APPEAL SUMMARY

Appeal ID: 19032	Project Address: 2834 SE Gladstone St
Hearing Date: 2/20/19	Appellant Name: Westin Glass
Case No.: B-007	Appellant Phone: 5033587235
Appeal Type: Building	Plans Examiner/Inspector: Maureen McCafferty
Project Type: commercial	Stories: 2 Occupancy: R-3, M Construction Type: V-B
Building/Business Name: Jolene's First Cousin	Fire Sprinklers: Yes - Throughout
Appeal Involves: Erection of a new structure	LUR or Permit Application No.: 17-237371-CO, 17-237384-CO
Plan Submitted Option: pdf [File 1] [File 2]	Proposed use:

Appeal item 1

Code Section 1812.3.2

RADON SSED DETAIL

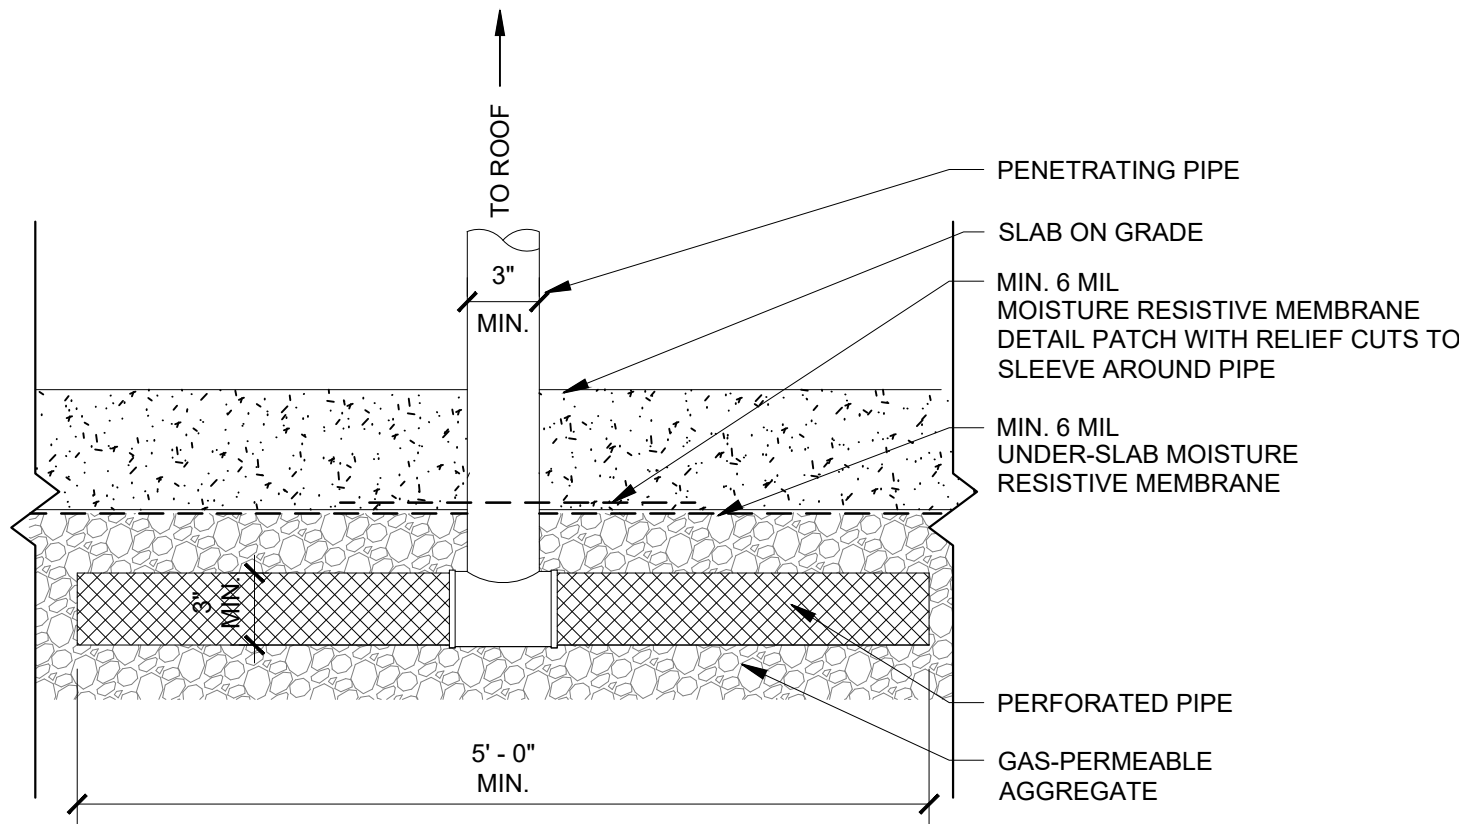
Proposed Design Due to a misunderstanding, the General Contractor used a "road base" 3/4" minus aggregate as the subslab layer, which does not meet the description of a "clean aggregate" as required by the code.

In the area immediately surrounding the radon Subslab Soil Exhaust System Ducts (SSESDs), he did use code-compliant "clean aggregate." This area extends approximately one foot from the SSESDs on all sides, and for the full depth of the subslab aggregate. (See attached photos.)

Reason for alternative Applicant believes that, given the low radon levels and existing soil makeup of the site, the subslab aggregate and SSESDs as installed, along with a soil-gas-retarder compliant with 1812.3.3, and proper sealing of entry routes compliant with 1812.3.4, will provide sufficient evacuation of any

small amount of radon that may be present on the site, and provide an acceptable level of protection from radon to the residents of the new building.

Since the subslab aggregate used does not qualify as gas-permeable, it would be safe to assume that any radon gas percolating through the soil below would be forced to migrate laterally through the silty layer until it reaches the permeable area surrounding the SSES, at which point it would be evacuated through the SSES to the open air above the building's roof.

Use of 3/4 inch minus road base gravel in lieu of gas-permeable clean aggregate: Hold for additional information. Proposal does not provide equivalent Life Safety protection.
